SUBJECT: H.B. ROBINSON STEAM ELECTRIC PLANT, UNIT NO. 2 - STAFF  
ASSESSMENT OF INFORMATION PROVIDED PURSUANT TO TITLE 10  
OF THE *CODE OF FEDERAL REGULATIONS* PART 50, SECTION 50.54(f),  
SEISMIC HAZARD REEVALUATIONS FOR RECOMMENDATION 2.1 OF THE  
NEAR-TERM TASK FORCE REVIEW OF INSIGHTS FROM THE FUKUSHIMA  
DAI-ICHI ACCIDENT (TAC NO. MF3724)

STAFF ASSESSMENT BY THE OFFICE OF NUCLEAR REACTOR REGULATION  
RELATED TO SEISMIC HAZARD AND SCREENING REPORT  
H. B. ROBINSON STEAM ELECTRIC PLANT, UNIT NO. 2  
DOCKET NO. 50-261

**Figure 3.2-1 Plot Comparing the Licensee's Mean Control Point Hazard Curves at a Variety of Frequencies for the H. B. Robinson Site. RAI Response Curves are Licensee Curves Developed Using the Currently Endorsed CEUS-SSC (NUREG-2115) for the H. B. Robinson Site**

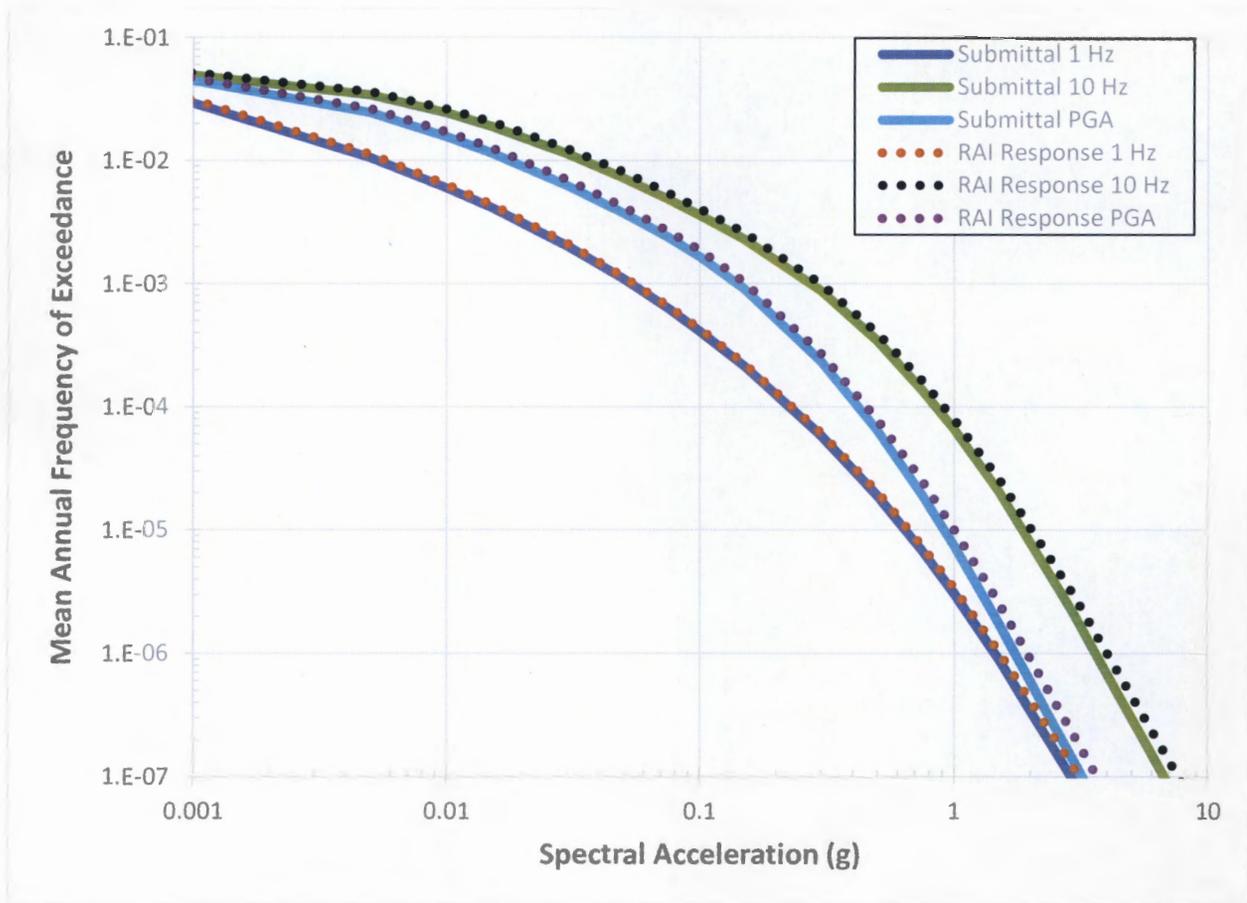
As part of its RAI response, the licensee provided control point hazard curves in order to show the impact of its refinements to the CEUS-SSC seismicity catalog. Figure 3.2-1 of this assessment shows the licensee's control point hazard curves developed using the as published CEUS-SSC and control point hazard curves developed using the modified CEUS-SSC. As shown in Figure 3.2-1 of this assessment, the impact of the licensee's changes to the hazard inputs have a very minor impact on the hazard for the Robinson site.

Figure 3.3-1 Plot of Staff's and Licensee's Base Case Shear-Wave Velocity Profiles for the Robinson Site.

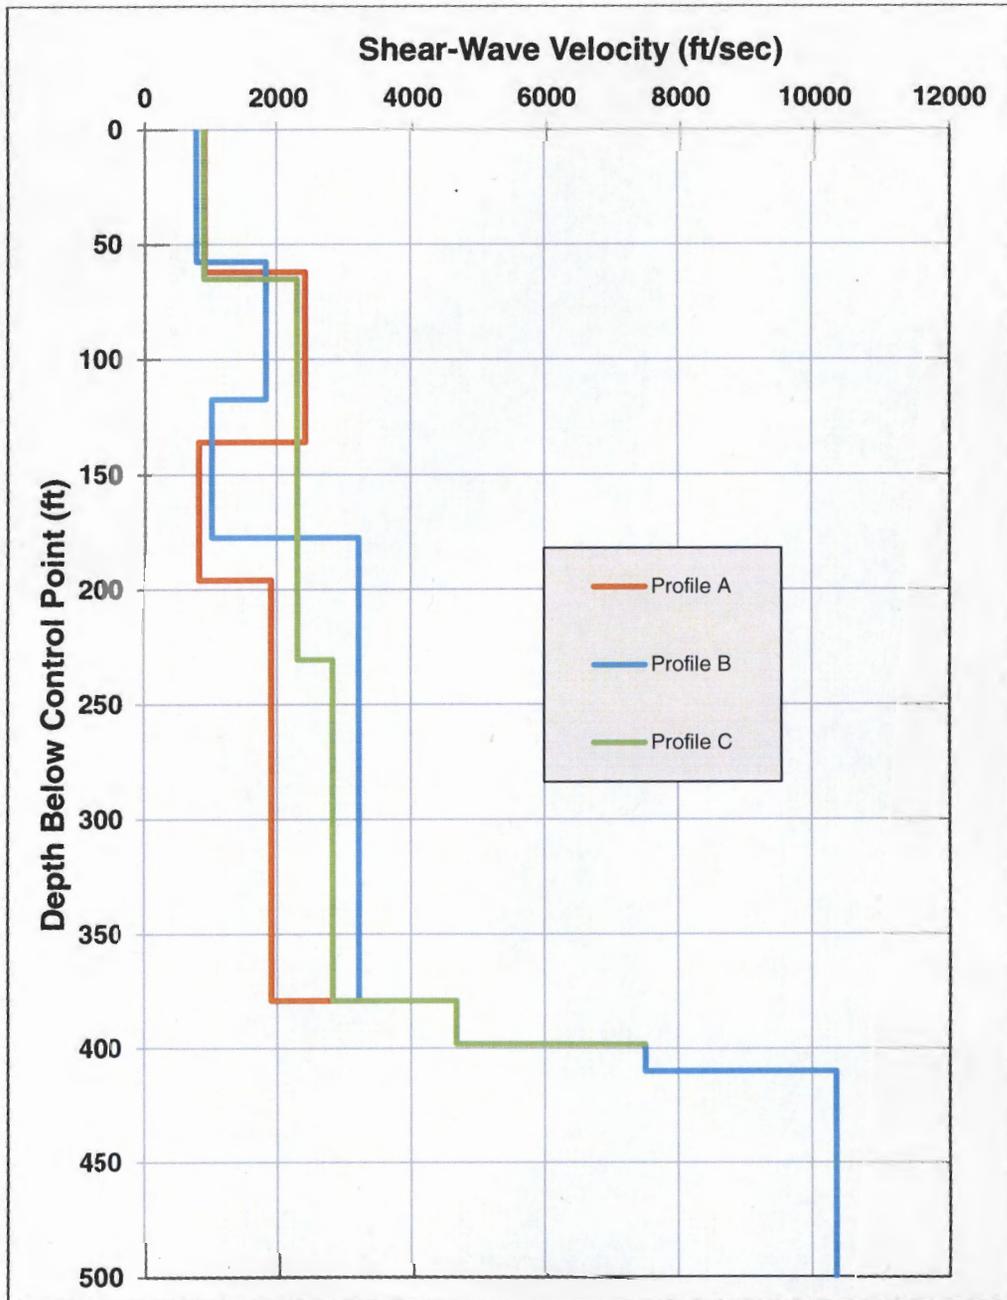
Because the recently collected geophysical data represents the most up to date information about the Robinson site, the NRC staff adopted profiles A-C as its base case profiles (Figure 3.3-1 of this assessment). The NRC staff weighed each profile equally, assuming that the differences in the profiles are representative of the epistemic uncertainty across the site. This approach differs from the licensee's approach, which gave greater weight to Profiles, B and C.

Figure 3.3- 2 Plot Comparing the Staff's and the Licensee's Median Amplification Functions and Uncertainties for the Robinson site.

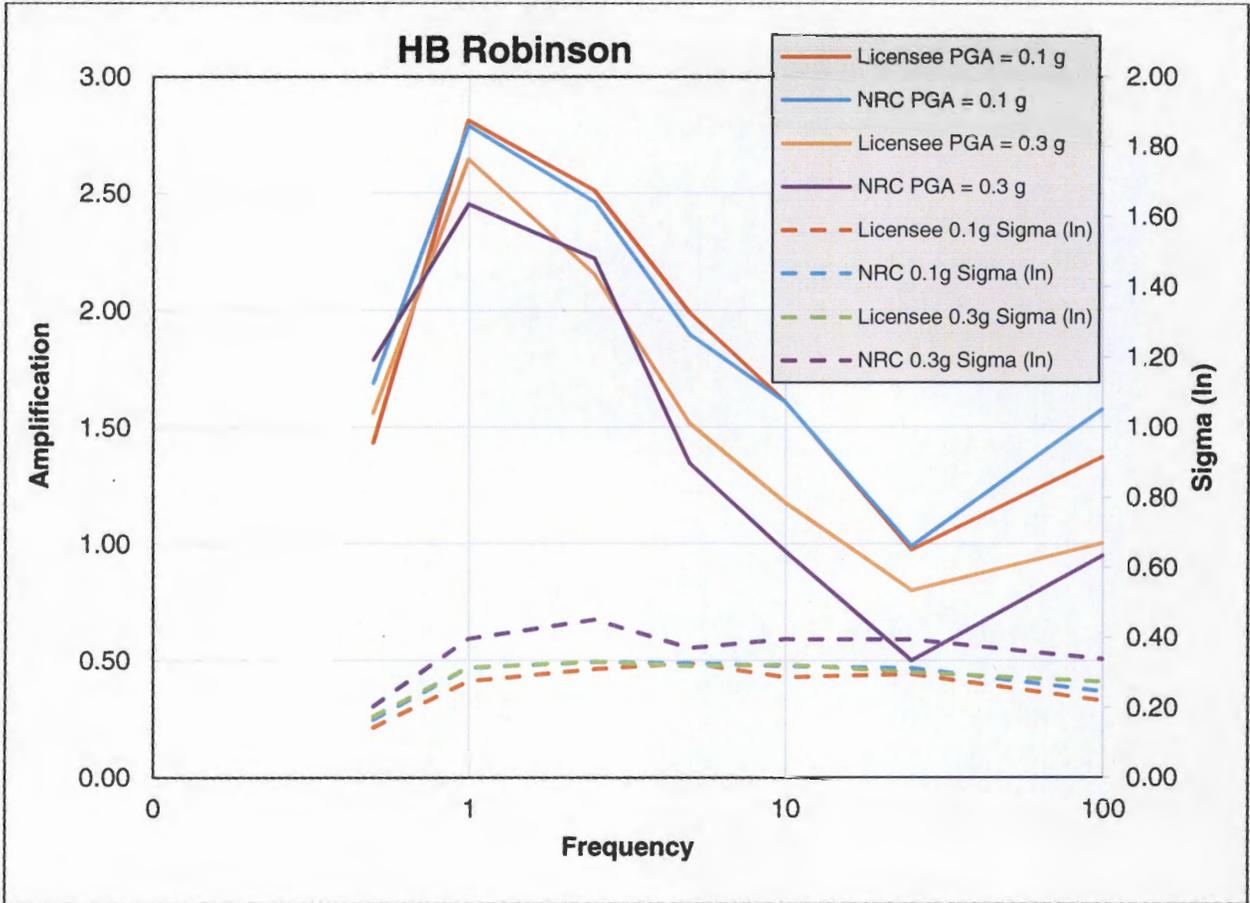
Figure 3.3-2 of this staff assessment shows a comparison of the NRC staff's and licensee's median site amplification functions and uncertainties ( $\pm 1$  standard deviation) for two input loading levels. The amplification functions and uncertainties calculated by the NRC staff and the licensee are similar. At high frequencies for the higher loading level, the licensee's site amplification is slightly higher than the NRC staff's, with uncertainties demonstrating opposite behavior. As shown in Figure 3.3-3 of this assessment, differences in the licensee's and NRC staff's site response analyses and PSHAs have only a moderate impact on the control point seismic hazard curves and the resulting GMRS, as discussed below. Differences in control point seismic hazard curves are greatest at low mean annual frequencies of exceedance (MAFE). These differences (up to 14 percent) are significantly lower at the  $10^{-4}$  and  $10^{-5}$  MAFE levels, which are used to calculate the GMRS. The NRC staff attributes these differences in

Figure 3.3-3 Plot Comparing the Staff's and the Licensee's Mean Control Point Hazard Curves at a Variety of Frequencies for the Robinson site.

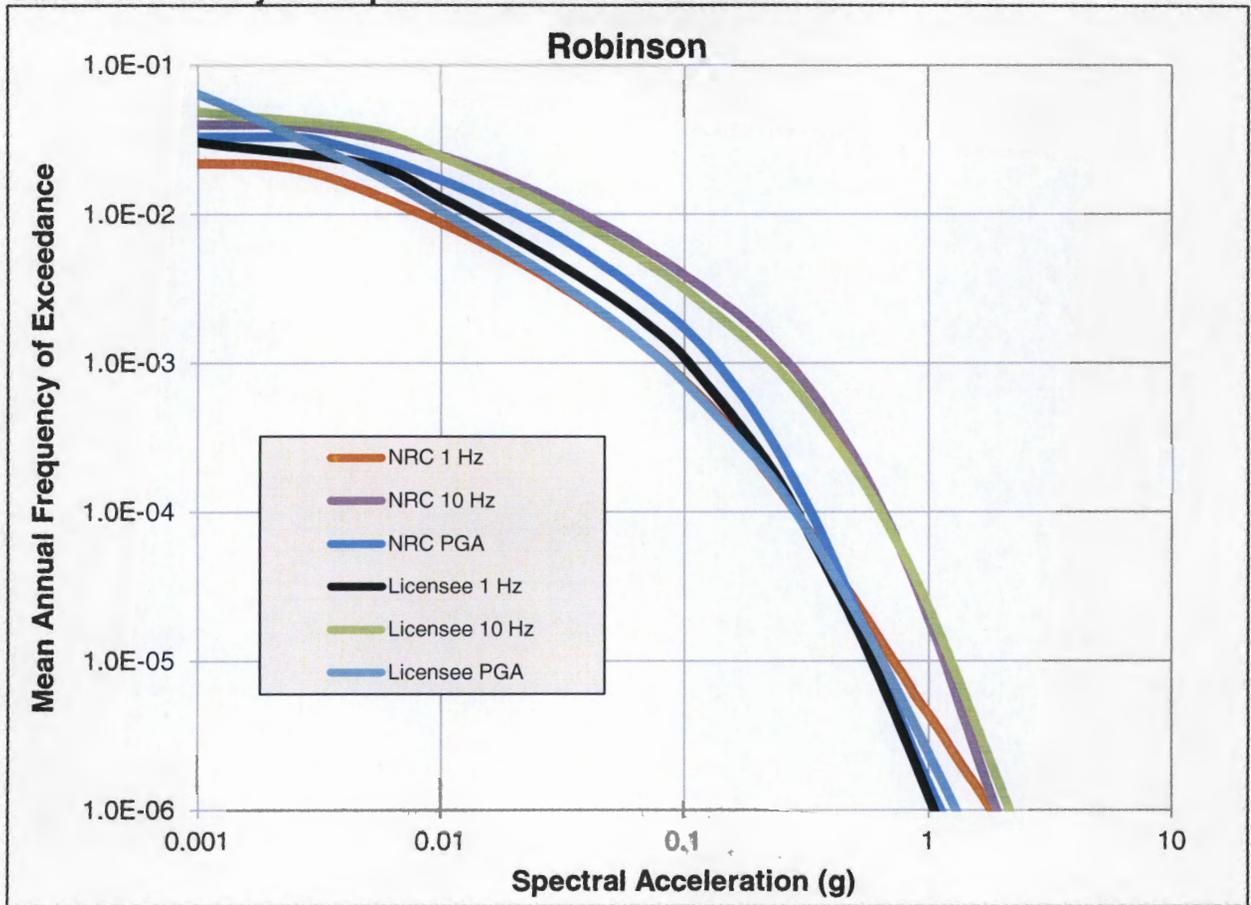
control point seismic hazard curves primarily to differences in the implementation of the CEUS-SSC model by the licensee.

Figure 3.4-1 Comparison of the Staff's GMRS with Licensee's GMRS and the SSE for the Robinson site

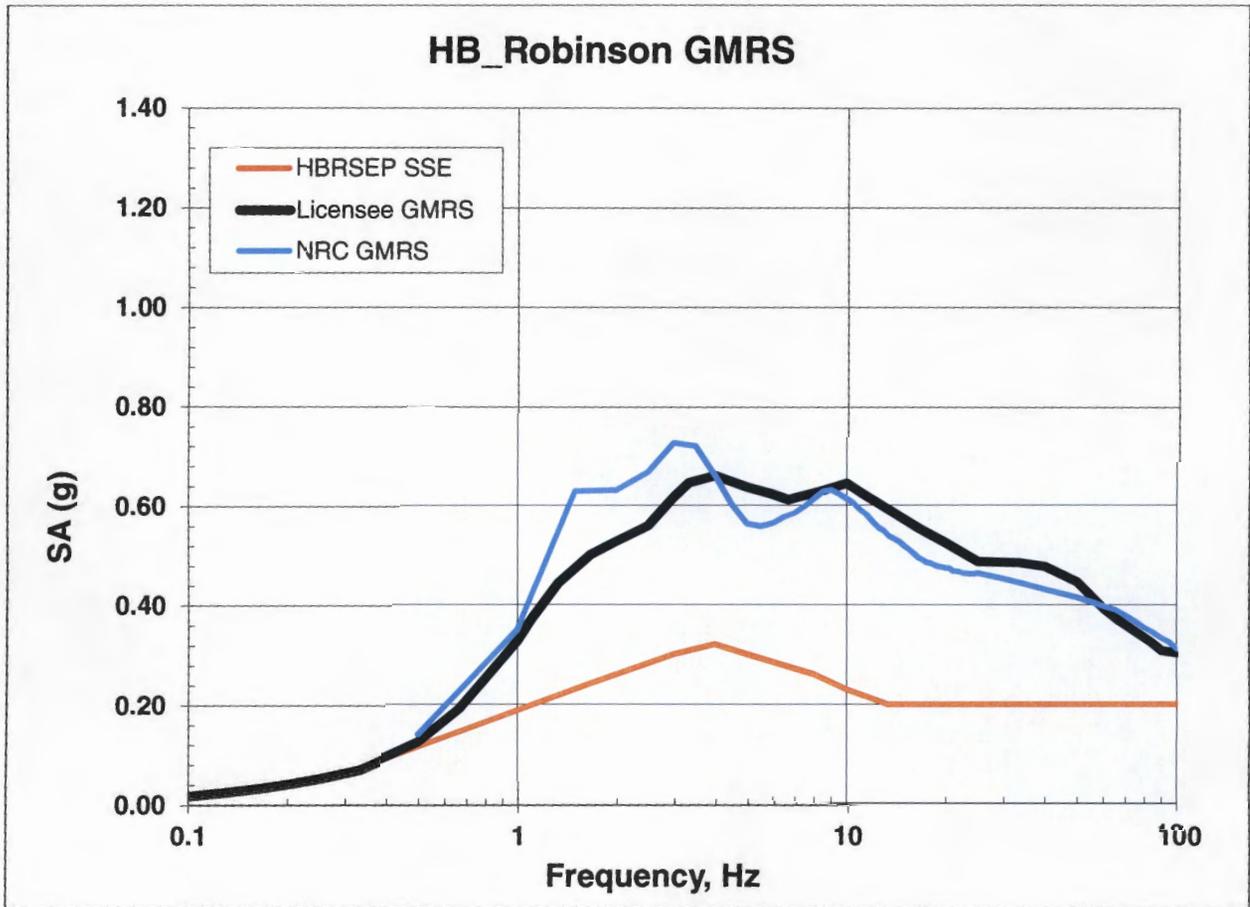
The NRC staff independently calculated the  $10^{-4}$  and  $10^{-5}$  UHRS using the results of its confirmatory PSHA and site response analysis, as described in Sections 3.2 and 3.3 of this staff assessment. Figure 3.4-1 of this assessment shows a comparison of the GMRS determined by the licensee to that determined by the NRC staff. As shown in Figure 3.4-1, the licensee's GMRS shape is generally similar to that calculated by the NRC staff with minor differences between 1.5 to 4.0 Hz.
